OUTCOMES COMMITTEE

Item Number. 5

SUBJECT: Public Exhibition - Villawood Town Centre Development Control Plan 2020 - Draft Amendment No.3
Premises: 1 Villawood Road Villawood Lot: 1 DP: 1013056
Applicant: DMPs (Daniel McNamara Planning Solutions)
Owner: ABA Holdings NSW Pty Ltd (Director/Secretary - Khaled Diab)
Zoning: E1 – Local Centre

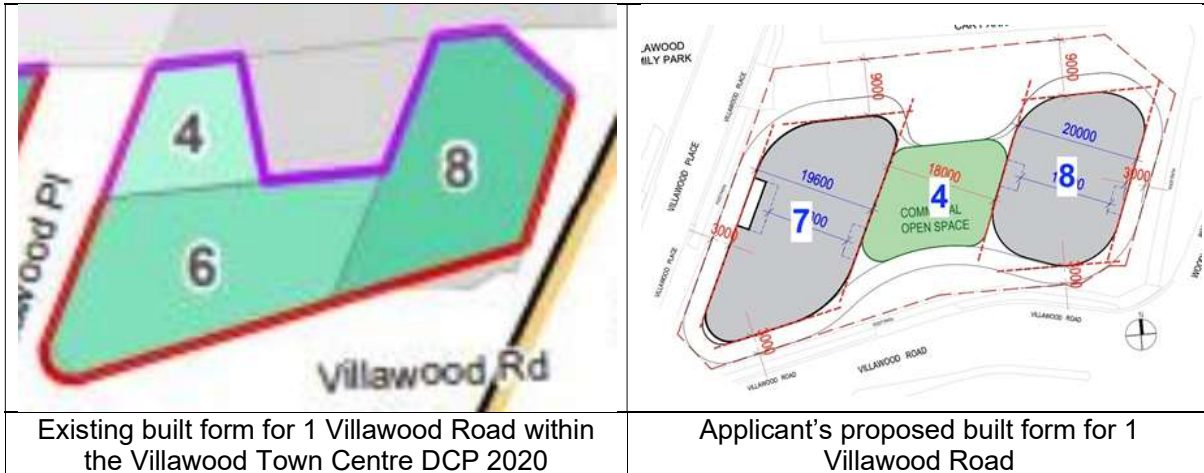
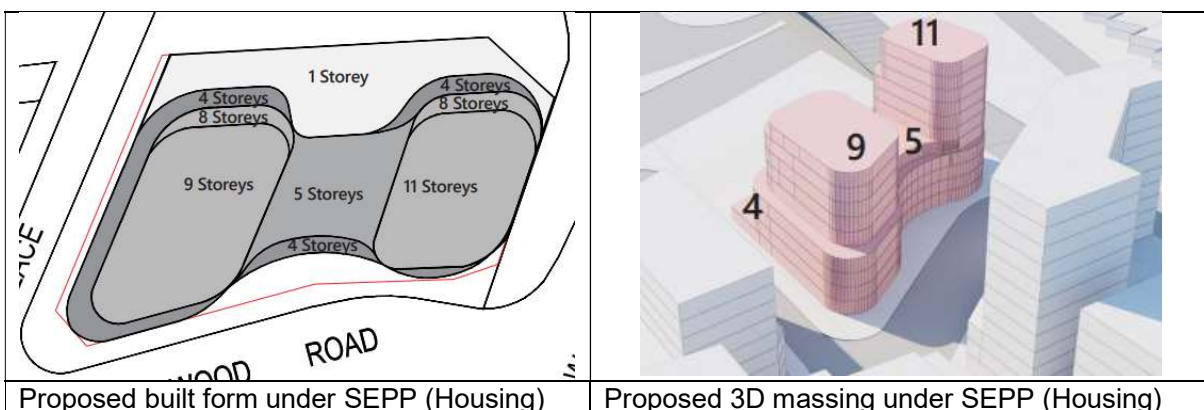
The diagrams below show the built form outcome envisaged in the existing DCP and the proposed built form by the applicant. The new proposal seeks a 'two tower' arrangement while the existing DCP envisages a single tower and associated permitted buildings decreasing in height to Villawood Place.

The Applicant's proposed built form amendments to the DCP do not exceed the maximum height of building on the Fairfield Local Environmental Plan 2013 Height of Building Map which is 27 metres (equivalent to 8 storeys).
